WATTS BAR NUCLEAR PLANT - REQUEST FOR ADDITIONAL INFORMATION  
(RAI) REGARDING RADIOLOGICAL IMPACT (TAC NO. MB1884)

ENCLOSURE  
TENNESSEE VALLEY AUTHORITY  
WATTS NUCLEAR PLANT (WBN)  
UNIT 1  
DOCKET NO. 390

**REVIEW OF RADIOLOGICAL  
CONSIDERATIONS FOR  
PRODUCTION OF TRITIUM AT  
WATTS BAR NUCLEAR PLANT**

**FIGURE 1 Sequoyah Unit 1 Cycle 10 RCS Tritium Concentration Vs Time**

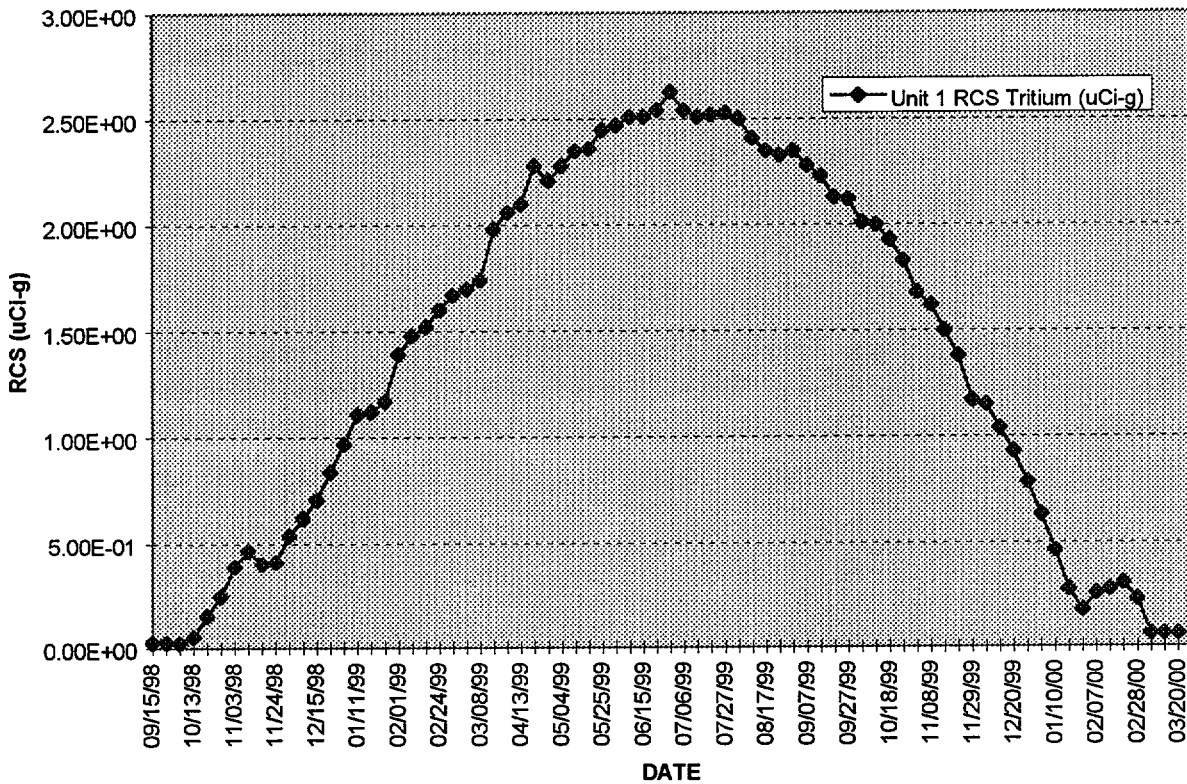
The RCS tritium concentrations from SQN Unit 1 Cycle 10 (continuous operation) are shown below in FIGURE 1 as an example. WBN Unit 1 Cycle 3 (continuous operation) demonstrated a similar pattern.
